Access Compliance Report Public Rights-of-Way (Curb Ramps)

Main Street: CROWN_VALLEY_PKWY Cross Street: N/A Location: S

ADA ID: RPRK211201112945 Ramp Type: Type 1 - Perpendicular Diagonal Initial Pass/Fail: Fail Overall Compliance: No Severity Score: 32

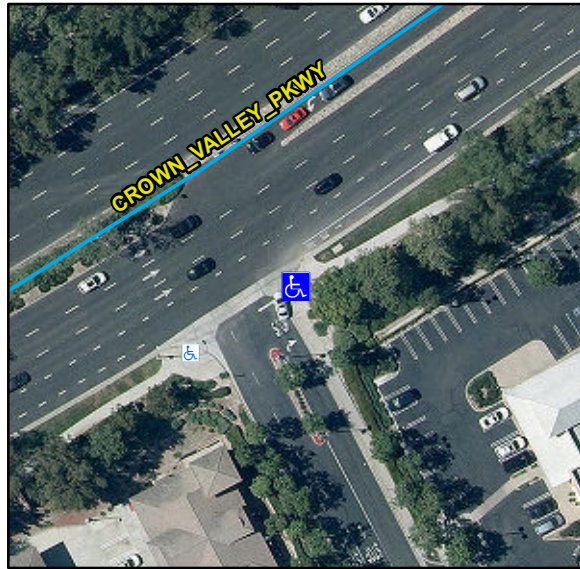
Compliance	Description	Data	Compliance	Description	Data
N/A	Ramp Length (in)	120	N/A	Flare Type LT	
Yes	Ramp Width (in)	54			N/A
No	Ramp Run Slope (%)	16.7	N/A	Flare Slope LT (%)	N/A
No	Ramp Cross Slope (%)	2.6	N/A	Flare Traversable LT	N/A
N/A	Landing Present	N/A	N/A	Flare Type RT	
N/A	Landing Length (in)	N/A			N/A
N/A	Landing Width (in)	N/A	N/A	Flare Slope RT (%)	N/A
N/A	Landing Run Slope (%)	N/A	N/A	Flare Traversable RT	N/A
N/A	Landing Cross Slope (%)	N/A	N/A	DWS Provided	N/A
N/A	Landing Movement Obstructed?	N/A	N/A	DWS Contrast	N/A
	Landing Movement Type	N/A	N/A	DWS Length (in)	N/A
N/A	Landing Shared	N/A	N/A	DWS Full Width	N/A
N/A	Clear Space	Yes	N/A	DWS Offset Left (in)	N/A
N/A	Clear Space To Crosswalk (in)	N/A	N/A	DWS Offset Right (in)	N/A
N/A	Marked Crosswalk 1	No	N/A	Marked Crosswalk 2	No
	Crossing 1 Direction	N		Crossing 2 Direction	W
	Marked Crosswalk 1 Width (in)	N/A		Marked Crosswalk 2 Width (in)	N/A

N/A	Ramp Inside Crosswalk 1	N/A	Yes	Ramp Inside Crosswalk 2	N/A
	Crossing 1 Slope (%)	8.3		Crossing 2 Slope (%)	14
	Crossing 1 Cross Slope (%)	5.9		Crossing 2 Cross Slope (%)	1.3
N/A	Gutter Ponding	N/A	No	Curb Slope	19.6
Yes	Gutter Lip Height (in)	0		Road Run Slope (%)	3.7
N/A	Gutter Run Slope (%)	N/A		Road Cross Slope (%)	6.4
N/A	Gutter Cross Slope (%)	N/A			
Yes	Overall Surface Condition: Acceptable		No	Perp Joint Present	No
	Cross Gutter Present?	Yes		Spandrel Present?	Yes
	Replace Cross Gutter?	No		Replace Spandrel?	No

Remove & Replace Curb Ramp With Two New Directional Ramps or Equivalent.

R304.2.2, R204.3, R304.5.3, STD 1115
